ADDENDUM NUMBER TWO (2)

Project: Replacement Facility for
Tippah County Hospital
Ripley, MS
PN: 18015

ADDENDUM NO. TWO (2) – CIVIL ENGINEERING ITEMS

Re: Replacement Facility for Tippah County Hospital – Addendum #2 (Electrical)

1 PARTIAL FLOOR PLAN - POWER PART A
E301A SCALE: 1/8"=1'-0"

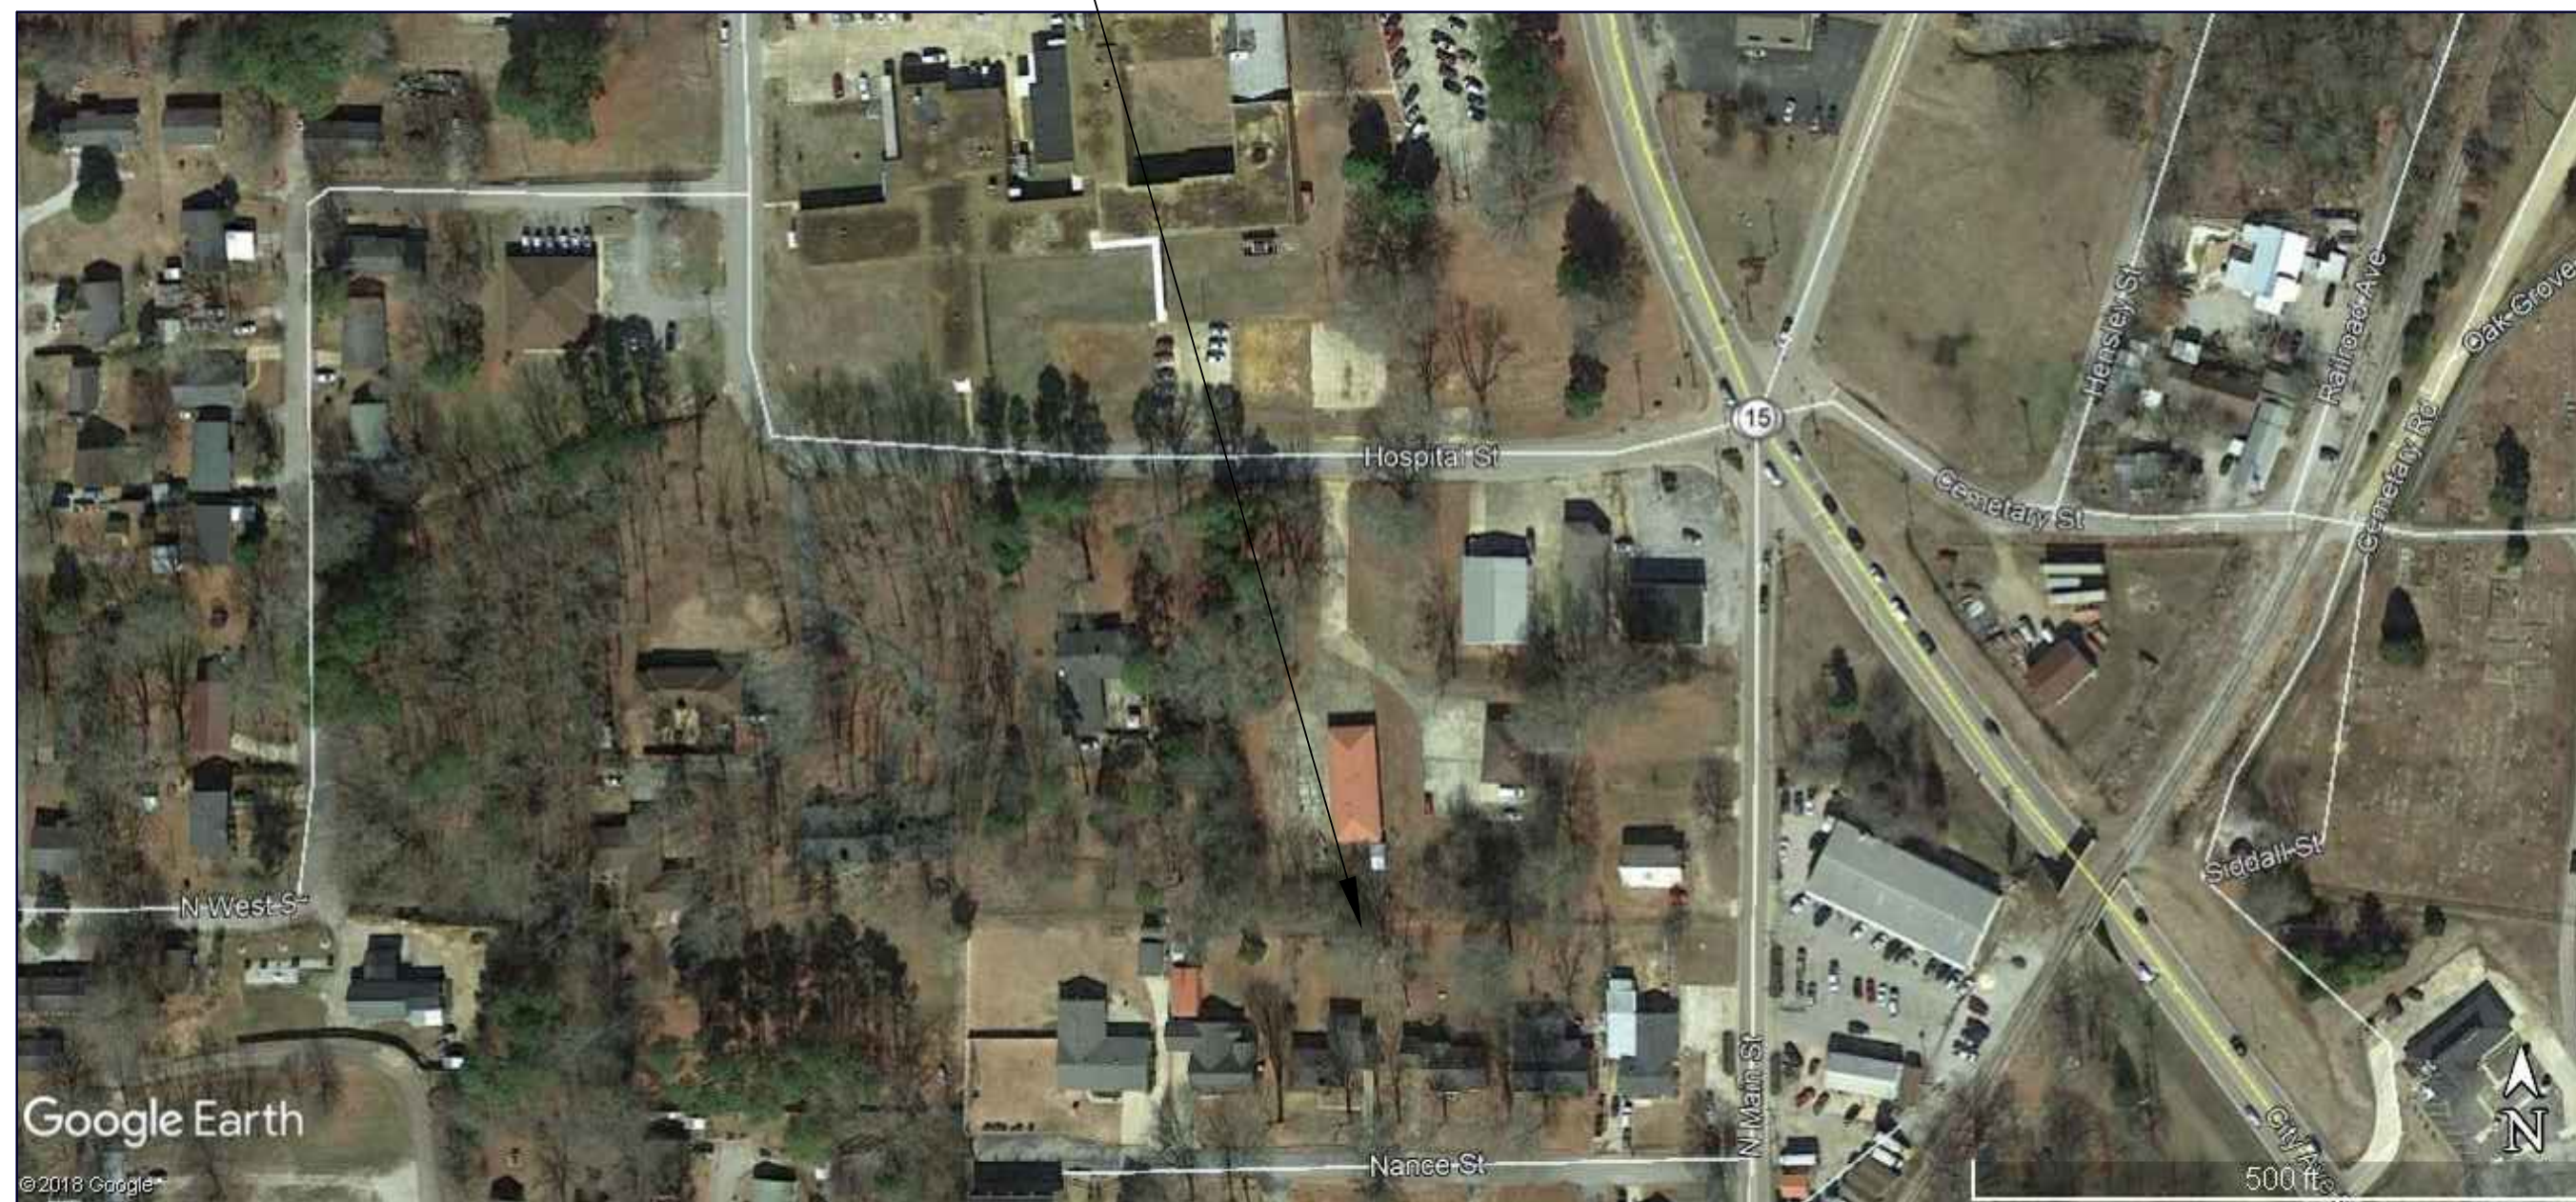
Sheet E301A

1. Floor box catalog number and electrical requirements have been added to this sheet.

- PROVIDE FLOOR BOX EQUAL TO WIREMOLD RFB2 WITH TWO DUPLEX RECEPTACLES. COVER SHALL HAVE NICKEL (NK) FINISH. (TYPICAL OF EIGHT)
 - PROVIDE FLOOR BOX EQUAL TO WIREMOLD RFB6 SERIES. SEE DETAIL 2/SHEET E606.

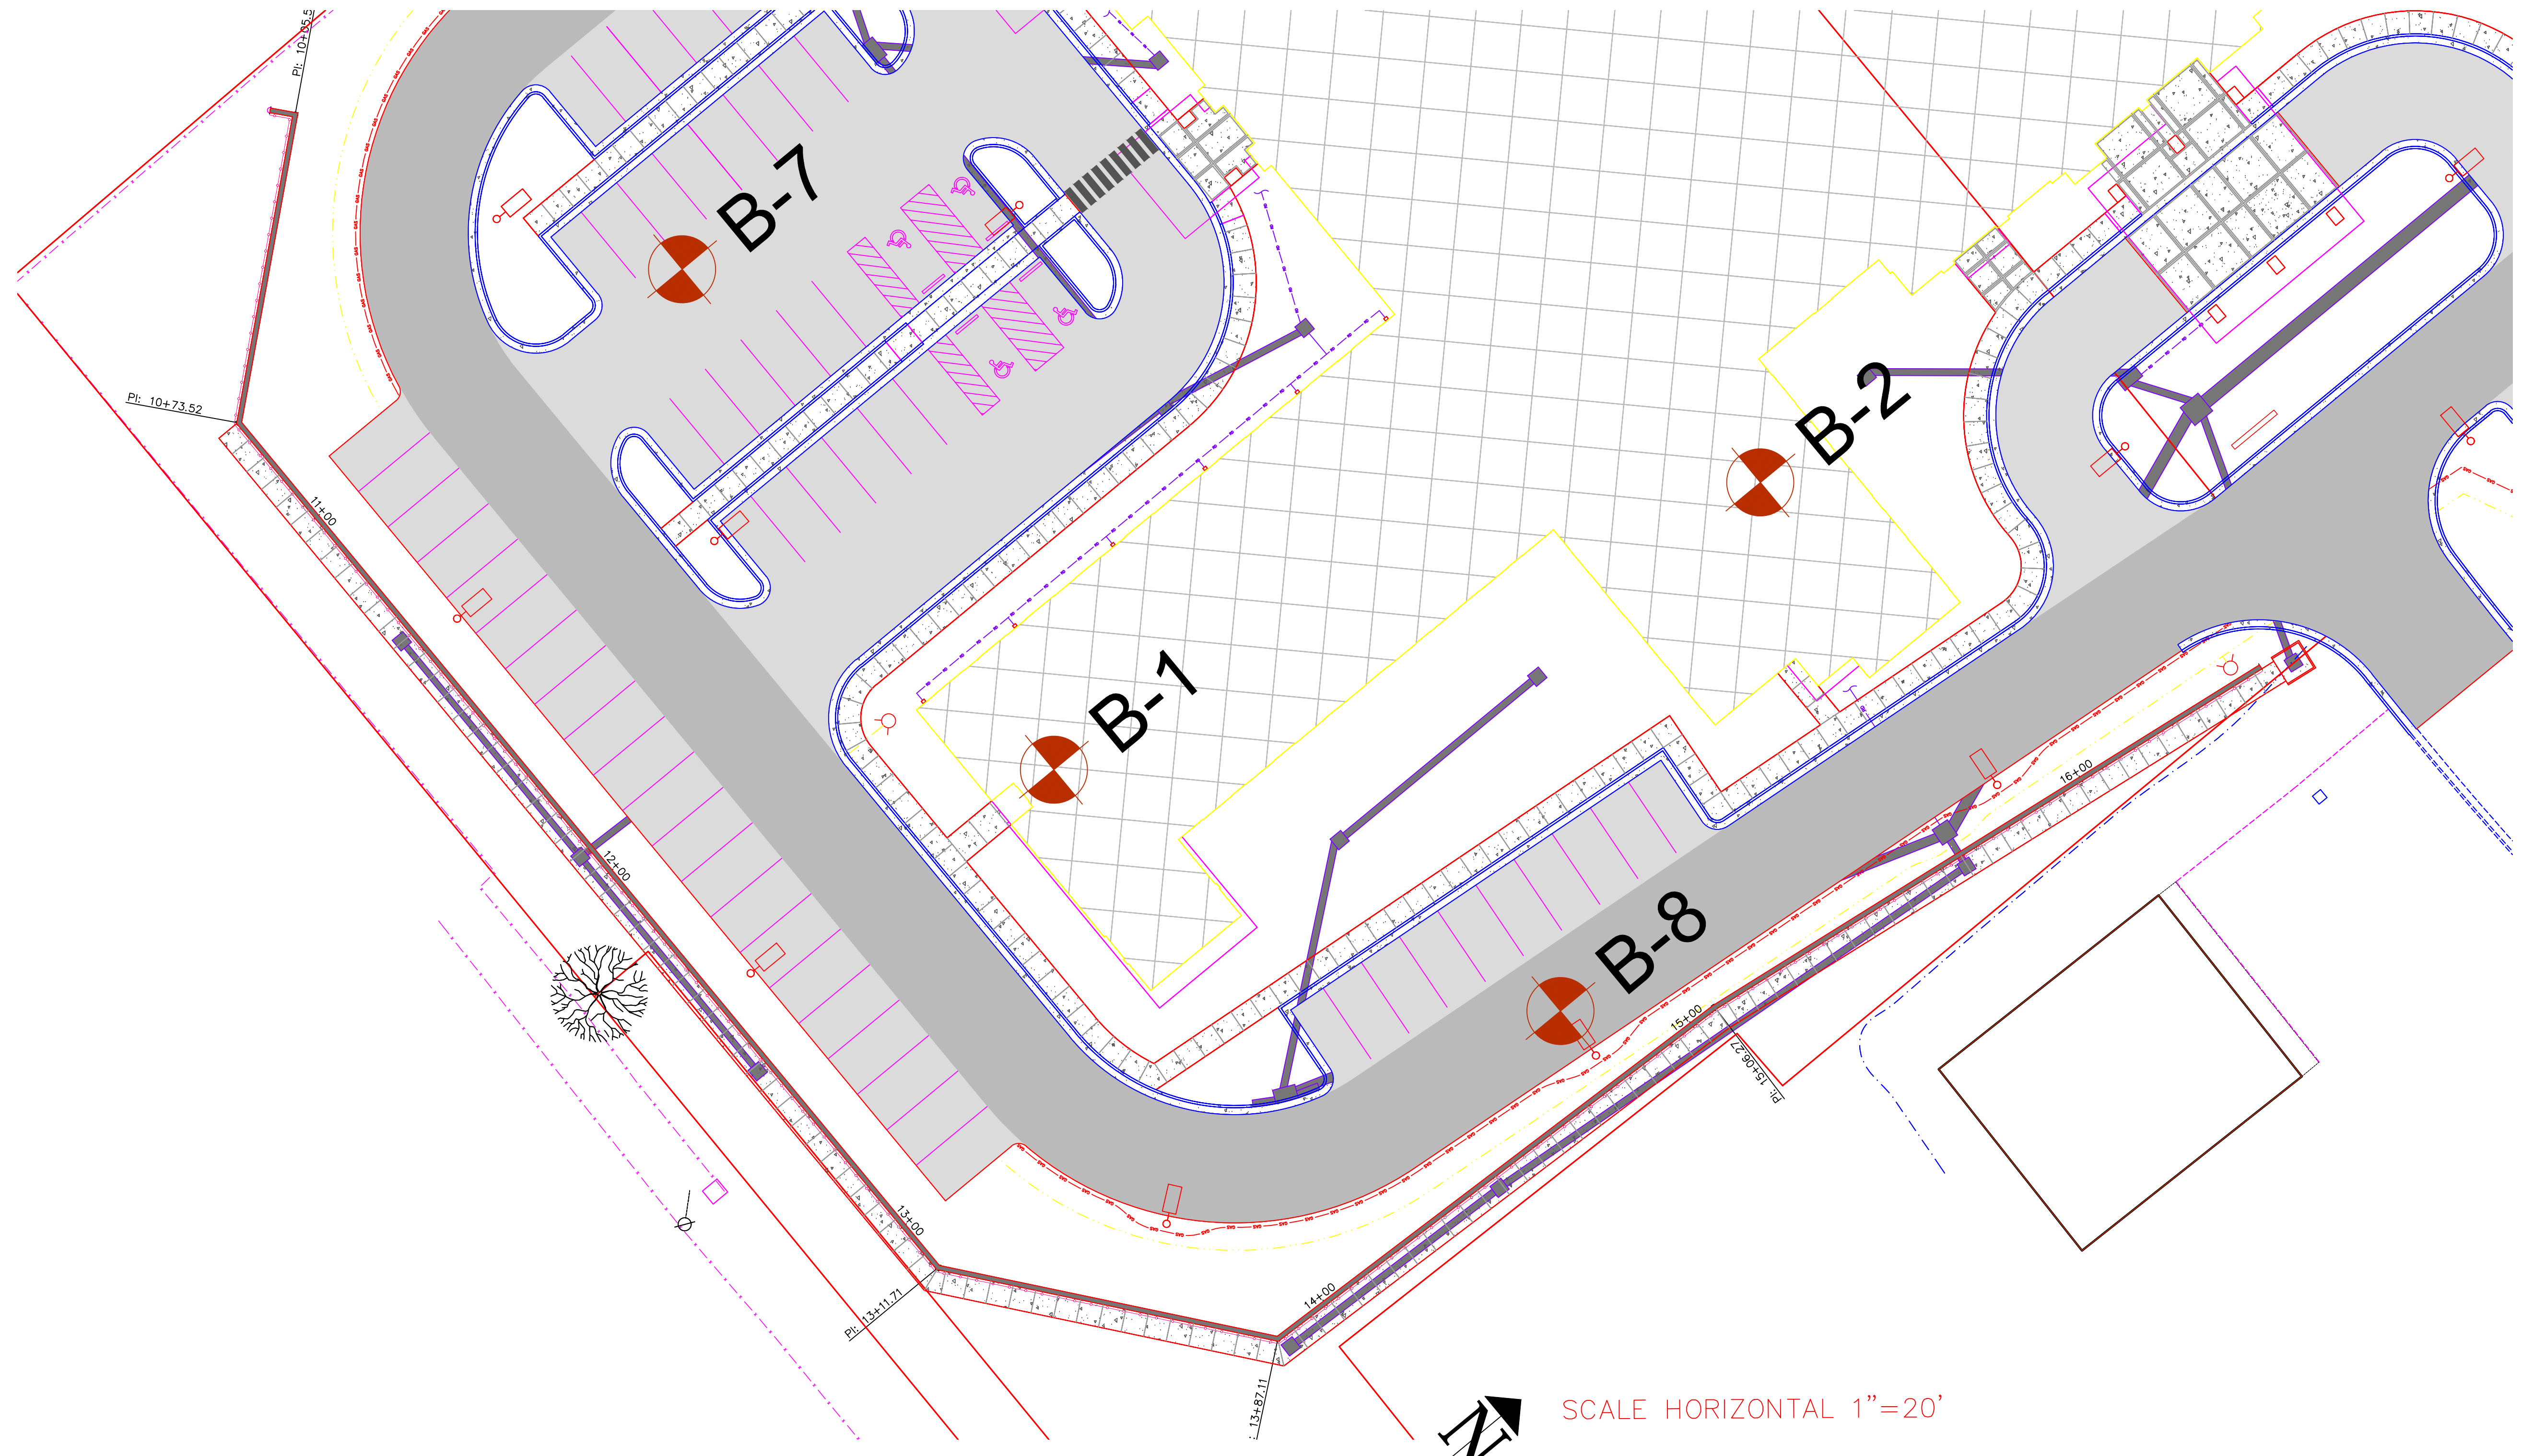
Item #1 - Add the four (4) enclosed construction drawings for the sheet pile retaining wall Sheets C7.0 thru C 7.3 provided by Precision Engineering Corporation dated 26 Dec 2019.
